Access Compliance Report

Public Rights-of-Way

(Curb Ramps)

Intersection ID: 12364	Main Street: W_1ST_ST	Cross Street: S_MINT_ST	Location: S
ADA ID: 435FEB8A2362	Ramp Type: Perp	Initial Pass/Fail: Fail	Overall Compliance: No
			Severity Score: 21.25

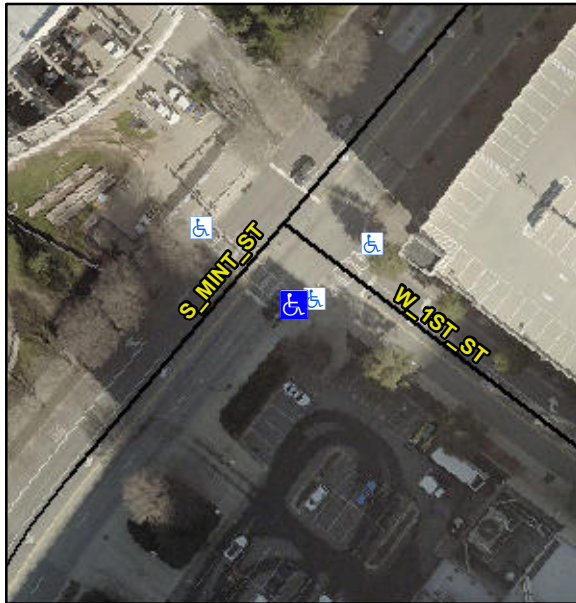
Not Found, R304.5.1, R304.2.2

Compliance	Description	Data	Compliance	Description	Data
N/A	Ramp Length (in)	70.0	No	Ramp Slope (%)	10.5
No	Ramp Width (in)	45.0	Yes	Ramp XSlope (%)	0.1
N/A	Flare Type LT	N/A	N/A	Flare Type RT	N/A
N/A	Flare Slope LT (%)	N/A	N/A	Flare Slope RT (%)	N/A
N/A	Flare Traversable LT?	N/A	N/A	Flare Traversable RT?	N/A
N/A	Landing Length (in)	N/A	N/A	DWS Provided?	N/A
N/A	Landing Width (in)	N/A	N/A	DWS Contrast?	N/A
N/A	Landing Slope (%)	N/A	N/A	DWS Length (in)	N/A
N/A	Landing X Slope (%)	N/A	N/A	DWS Full Width?	N/A
N/A	Landing Curb? (Y/N)	N/A	N/A	DWS Offset (in)	N/A
N/A	Shared Landing?	N/A			
N/A	Gutter Ponding?	N/A	N/A	Gutter Slope (%)	N/A
N/A	Gutter Lip Ht (in)	N/A	N/A	Gutter X Slope (%)	N/A
N/A	Painted X Walk1?	Yes	N/A	Painted X Walk2?	N/A
	X Walk 1 Direction	To NW		X Walk 2 Direction	N/A
N/A	X Walk 1 Width (in)	109.0	N/A	X Walk 2 Width (in)	N/A
	X Walk 1 Slope (%)	5.3		X Walk 2 Slope (%)	N/A
	X Walk 1 X Slope (%)	0.3		X Walk 2 X Slope (%)	N/A

Remove & Replace Entire Ramp.
